Report Committee of Adjustment

June 14, 2024 September 17, 2024
A-2024-0222
Daniels MPV 2 Corporation
0 All Nations Drive
WARD 6

FIGURE A & B: TH-6 & TH-2

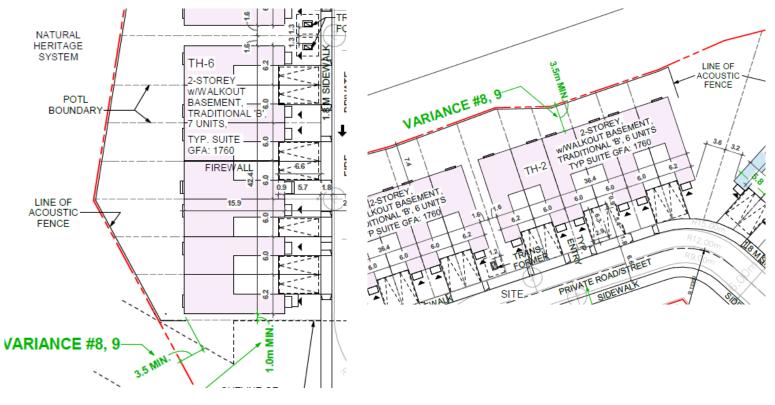
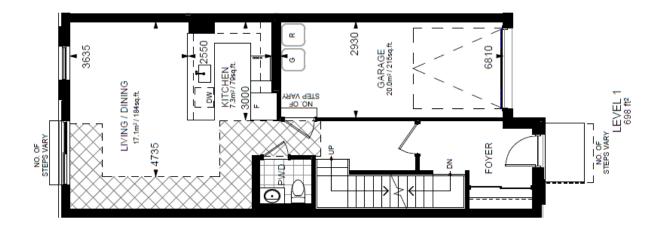
Variance 9 seeks to allow the rear wall of street townhouse dwellings in Blocks TH-6 and TH-2 (Figure A & B) to be setback a minimum 3.5m from an Agricultural (A) or Floodplain (F) zone. The intent of the By-law's setback requirement is to maintain sufficient separation of land uses and prevent adverse impacts on the abutting Floodplain zone. As part of this review, the Credit Valley Conservation authority

(CVC) was consulted regarding the reduced setbacks. CVC staff expressed no concerns, as the overall detailed design submitted through the associated Draft Plan of Subdivision 21T-19017B has already been approved, with permits issued for the development in the Regulated Area (ie, grading and outfalls into the Natural Heritage System). Previous reviews ensured that regulated features and appropriate setbacks were included within the NHS block.

Variance 11 is requested to permit up to 31% of the townhouse or street townhouse dwelling units to have a dwelling unit width of 5.6m and up to 10% of the townhouse or street townhouse dwelling to have a dwelling unit width of 5.8m. The intent of the By-law in prescribing a minimum unit width is to ensure sufficient internal space to meet building code requirements and maintain landscaped open space (external) are considered. As part of this review, a meeting between City staff and the applicant addressed concerns about landscaped open space, which will continue to be reviewed through the Site Plan process. Building staff have reviewed and evaluated the provided floorplans and found them to meet minimum building code requirements for internal habitable space(s) and further subject to building permits being applied (Figure C).
